Docket Item # 3
BAR CASE # 2017-00397

BAR Meeting
November 15, 2017

ISSUE: Alterations (shutters and fence)

LOCATION: 608 South Fairfax Street

FRONT / WEST ELEVATION LANDSCAPE WALL PROPOSAL - EXISTING VS PROPOSED

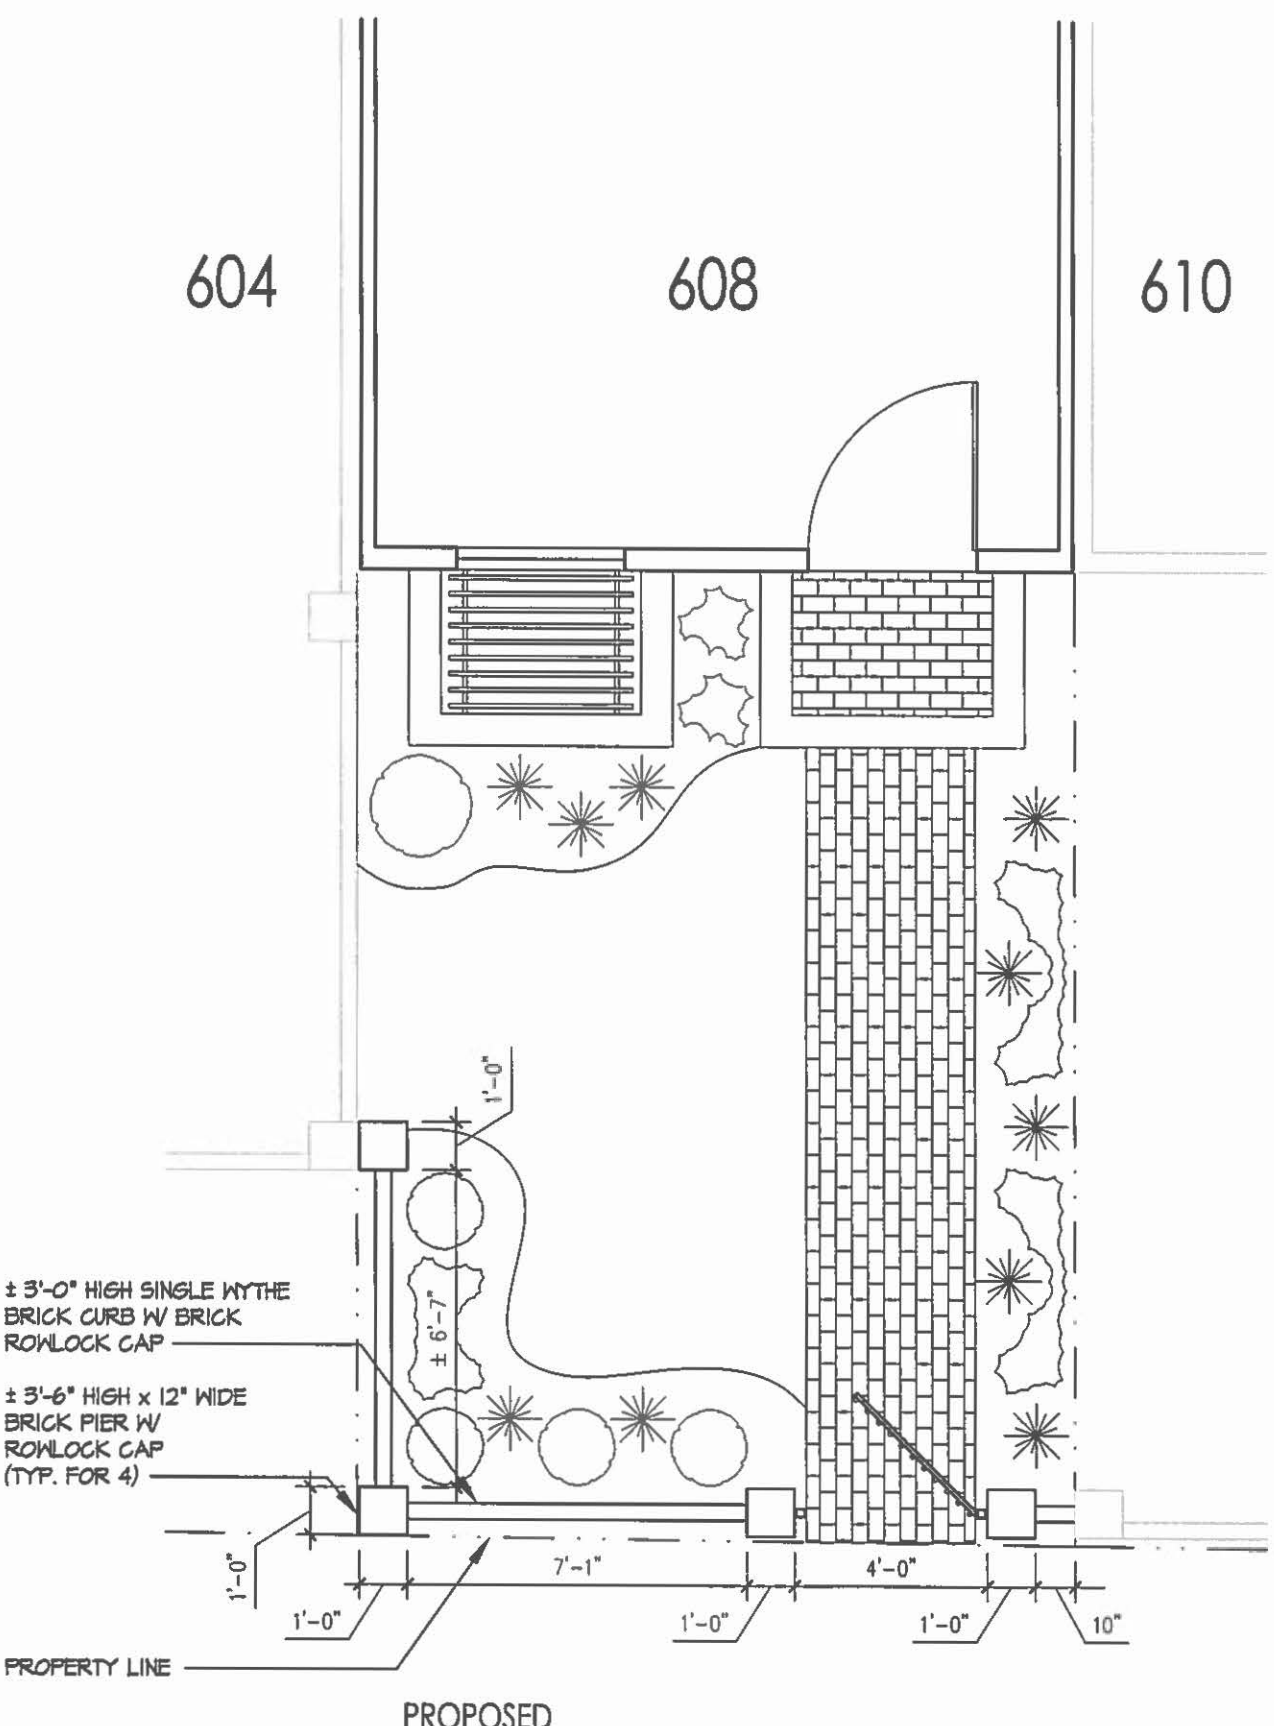
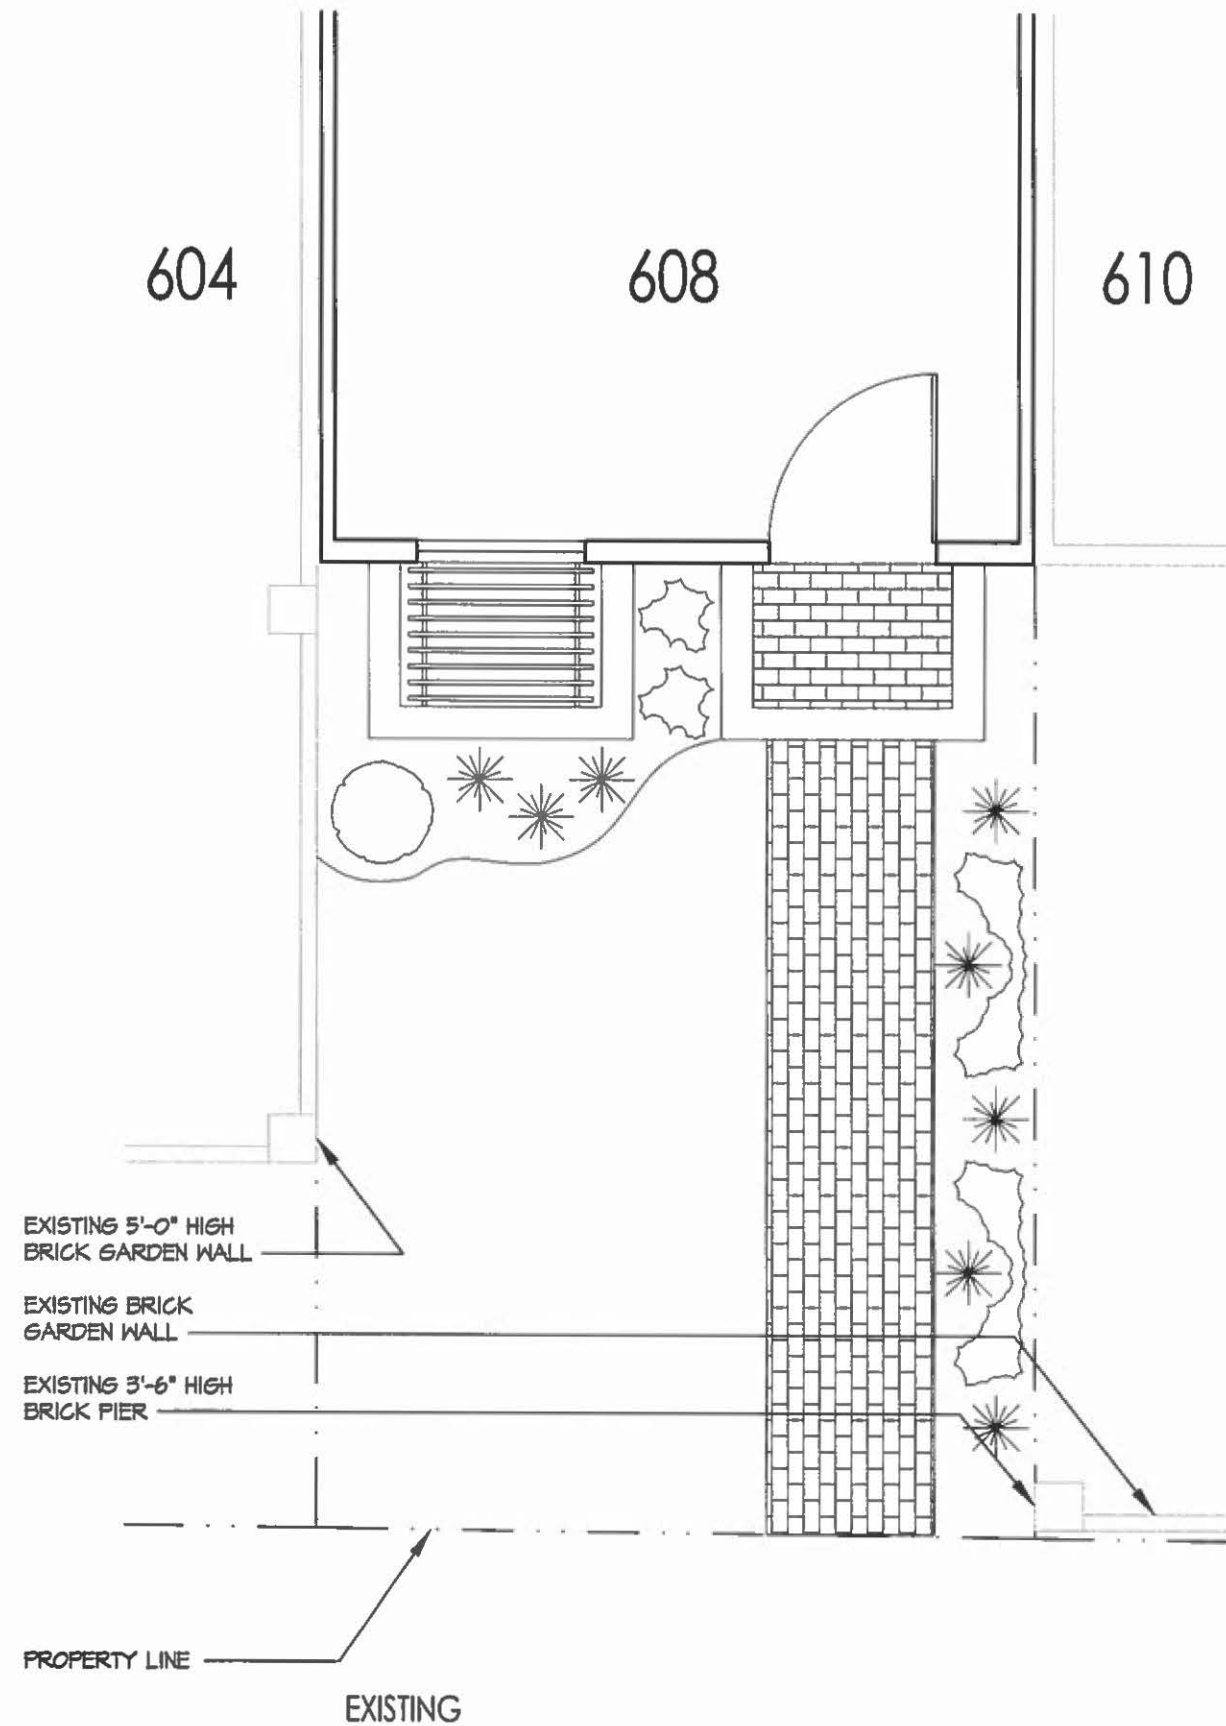
In addition, the applicant requests approval for the construction of a brick fence and wrought iron gate along the west property line as well as the open segment along the north property line adjoining 604 South Fairfax Street. The height of the brick wall will be 3 feet and the piers will be 3.5 feet. The brick and mortar of the wall and piers will match the existing entry stoop. The wrought iron gate will be constructed of solid square-stock wrought iron with pyramidal caps to be painted black to match the entry door and shutters. The intention is to complement the brick garden wall designs of the adjacent properties to the north and south with the brick wall and with piers matching the height and width of those found next door at 610 South Fairfax which the BAR recently approved. The wrought iron gate is intended to provide security and separation, while maintaining public visibility of the landscaped garden.

The proposed brick fence and wrought iron gate will match the existing entry stoop and complement the adjacent properties' brick walls. The BAR's *Minor Architectural Elements* policy permits staff approval of: "New rear and interior side yard fences and gates up to 6' high and replacement of existing front yard fences up to 3.5' high may be administratively approved if they meet zoning requirements (a plat is required to confirm compliance) and are constructed of stylistically appropriate wood or metal." In the RM zone, a required front yard is the yard area that is forward of the "...average distance of the existing buildings from the front lot line..." Because the majority of the buildings on this block are constructed at the front lot line, the average setback is very close to that front lot line. Therefore, the proposed fence is not in a required front yard and could likely have been approved administratively by staff. However, it has been staff's practice since adoption of the policy to take new fences to the BAR for review that are located in front of a street-facing elevation of the building because of their prominent visibility from a public way and potential impact on the architectural character of the structure and site. Staff supports the proposed brick wall with piers and notes that the 3 feet height and open wrought iron gate will continue to permit visibility into the front yard.

C-3 Proposed new brick wall with wrought iron gate along the front and side property lines require waiver from the board of architectural review board (section 7-202(C)).

Staff recommends approval of application for window shutters and a brick fence with a wrought iron gate, as submitted.

LANDSCAPE WALL PLAN PROPOSAL - EXISTING VS PROPOSED

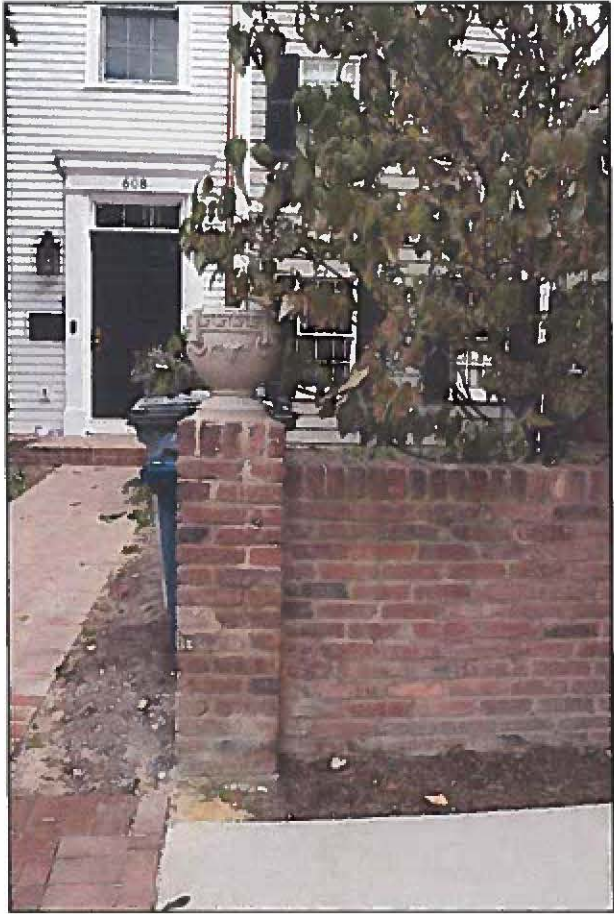
C-1 Proposed brick wall along the side property line requires waiver from the board of architectural review board (section 7-202(C)).
